Deck Mounted 8" Fixed Centers Concealed Hot and Cold Water Sink Faucet

Shop Drawing Submittal Review

Project Name: Webster University-**ISB**

SPEC SECTION: 22 4216.16
Commercial Sinks

SK-3 SINK

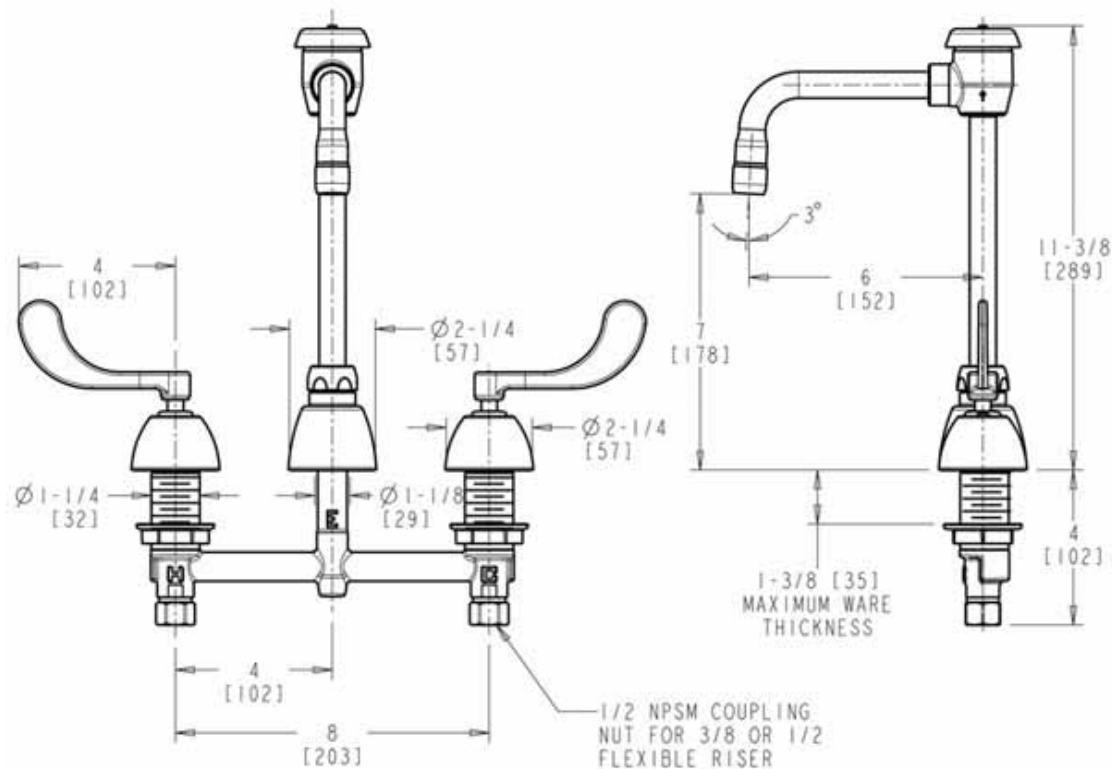
S/S SINK BASKET STRAINER W/ 1-1/2" CP BRASS TAILPIECE
1-1/2 SEMI CAST P TRAP W/CO CP
LF 1/2" NOM COMP X 3/8" OD COMP W/ LOOSE KEY
12" X 3/8" OD LAVATORY SUPPLY LINE
5/8" OD CP SHALLOW ESC FLANGE
~~COVER FOR TRAP / HOT & COLD STOP & SUPPLY~~
~~LEAD LAW COMPLIANT 3/8 THERMOSTAT TEMPERING VALVE~~

1. Sink is integral with the counter-top. Coordinate with the architectural drawings.
2. Provide under counter waste and supply protective piping covers as required.
Verify requirements with the architectural drawings.
3. Escutcheons are specified to be cast brass. Refer to specification section 220518.
